MECHANICAL RENOVATIONS
BOYET JUNIOR HIGH SCHOOL
59295 Rebel Dr.
Slidell, LA 70461

SHEET TITLE: DEMO PLAN

DRAWING NUMBER: D101

1 DEMO PLAN
SCALE: 1/8"= 1'-0"

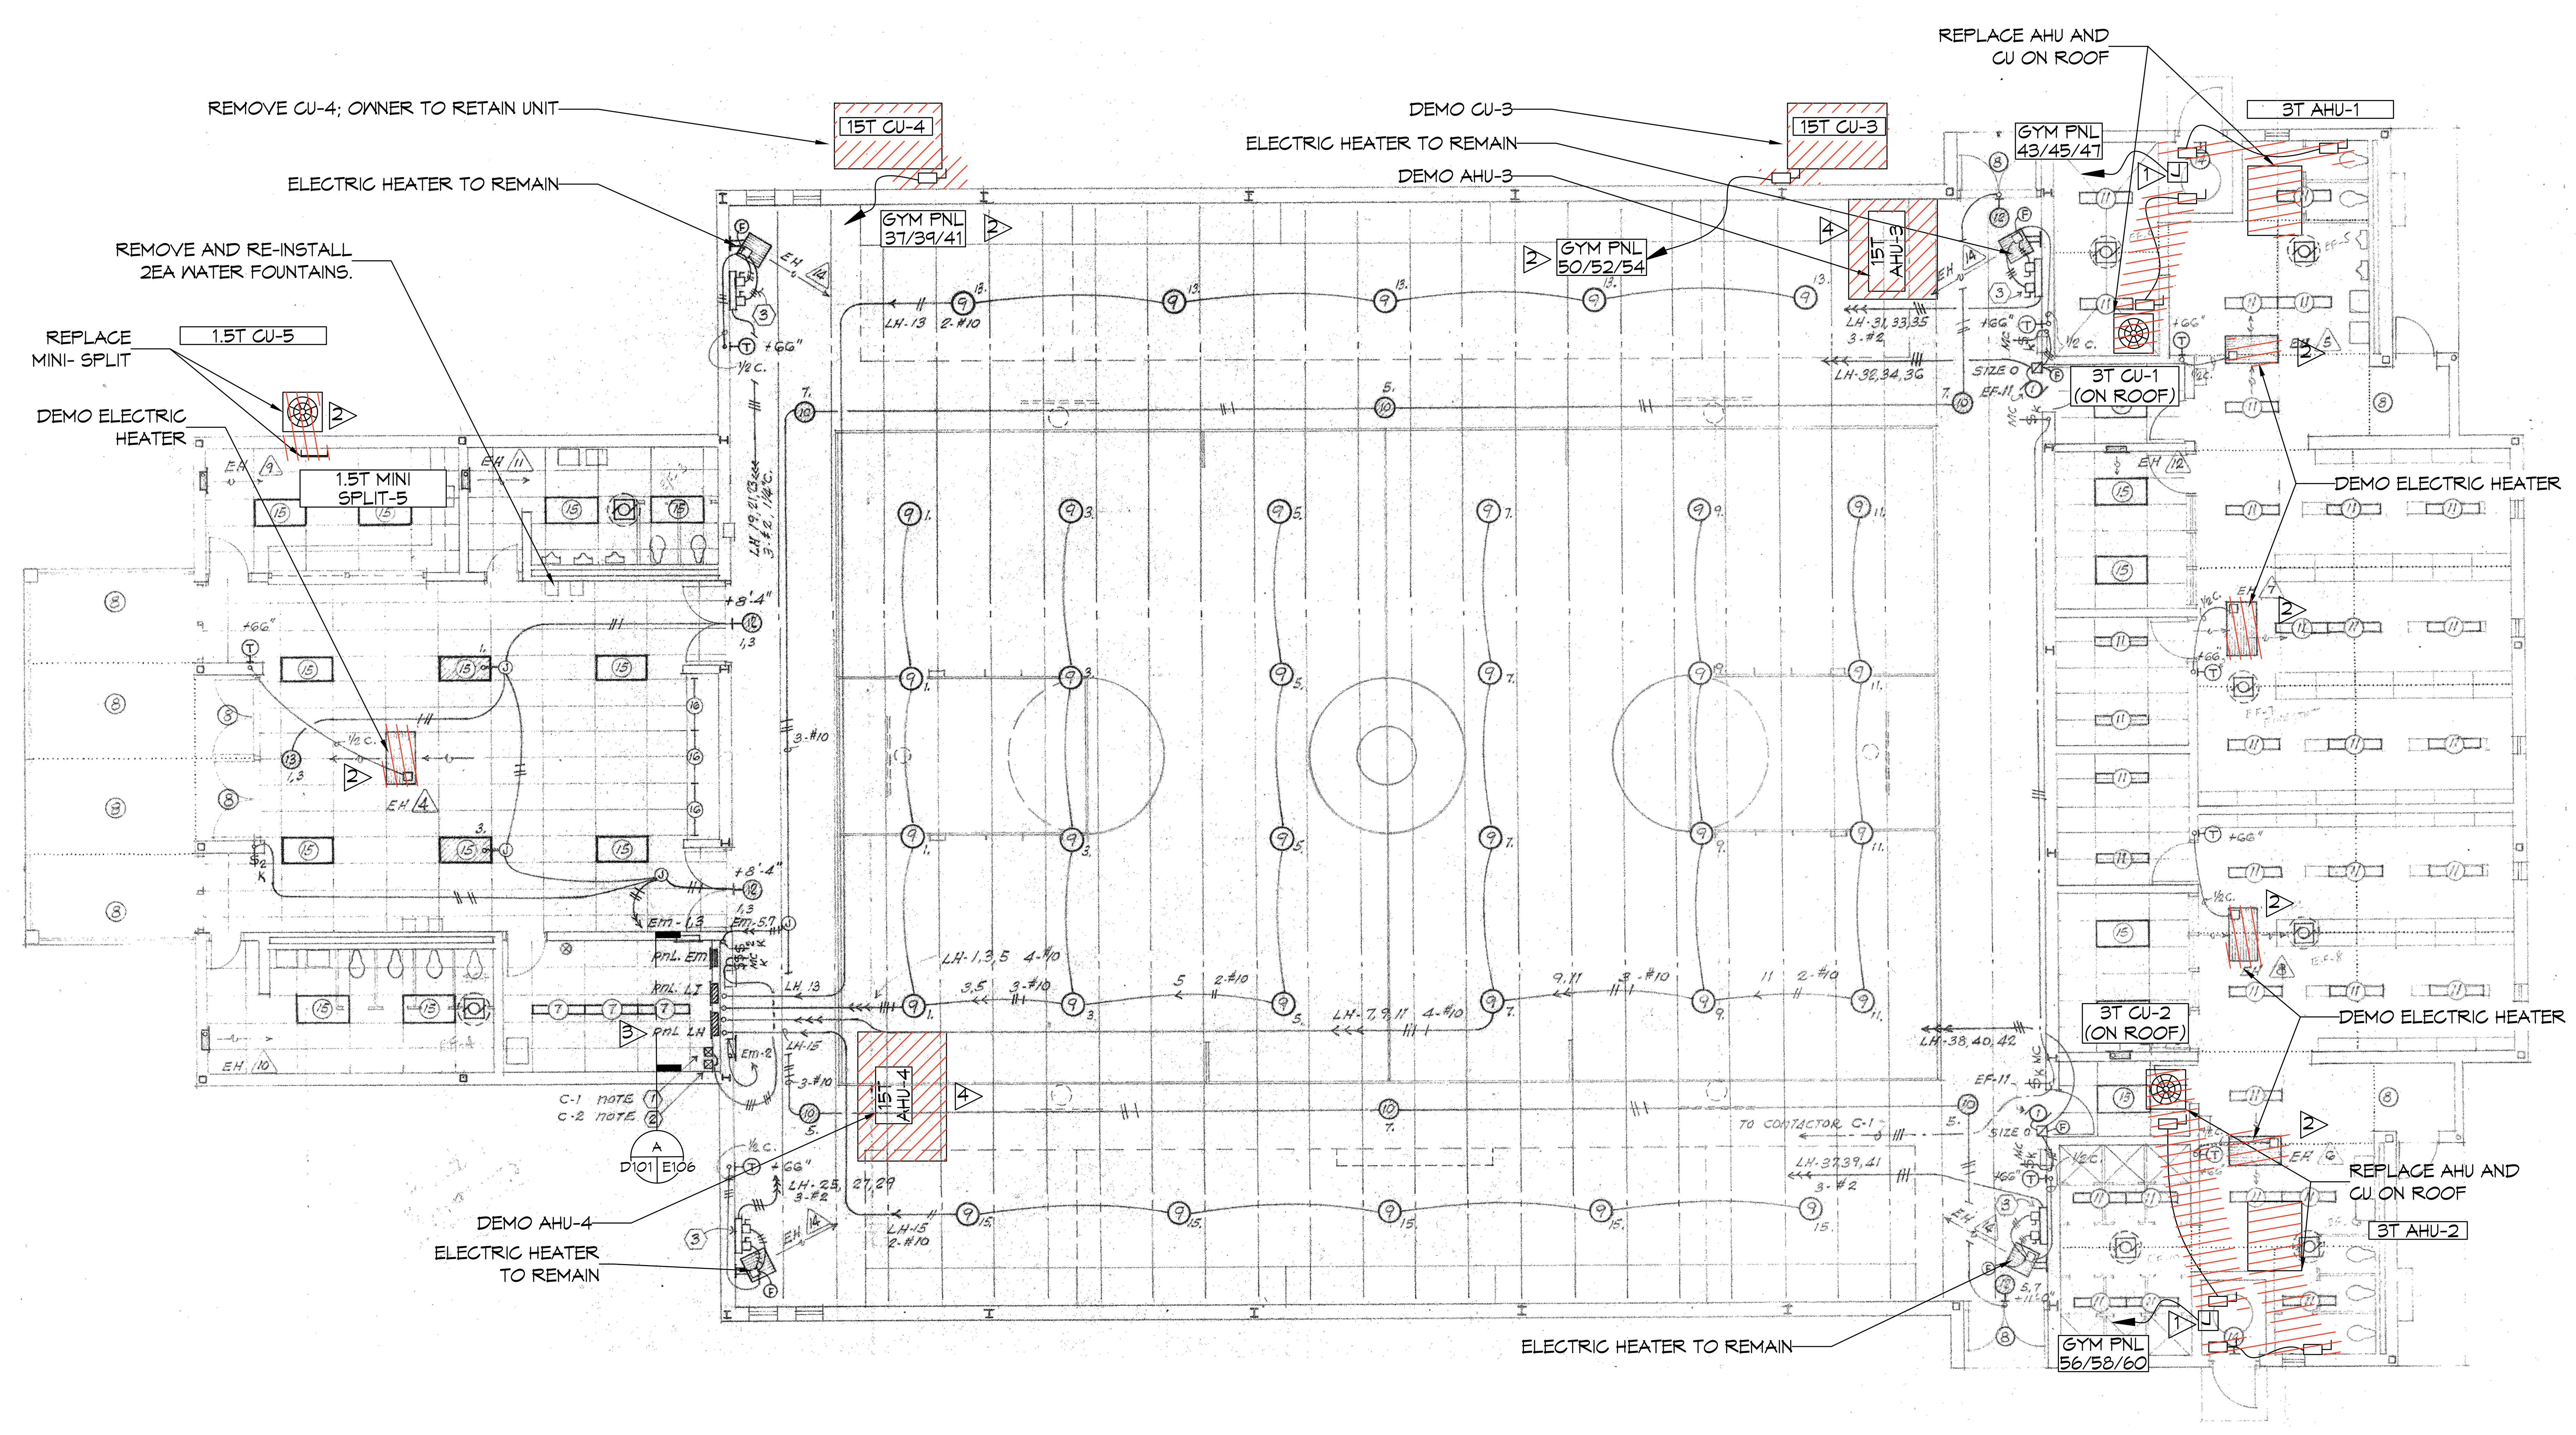
Addendum #1 - Change note #2 to read : "Trace out Conduit and Wire, remove wire back to source. Remove wire from breaker and label breaker as spare. If conduit cannot be re-used, install Junction Box at end of run. Seal any penetrations through exterior walls"

Addendum #1 - Change note #3 to read : "Existing GYM Panel shall be repaired per the Electrical plans."
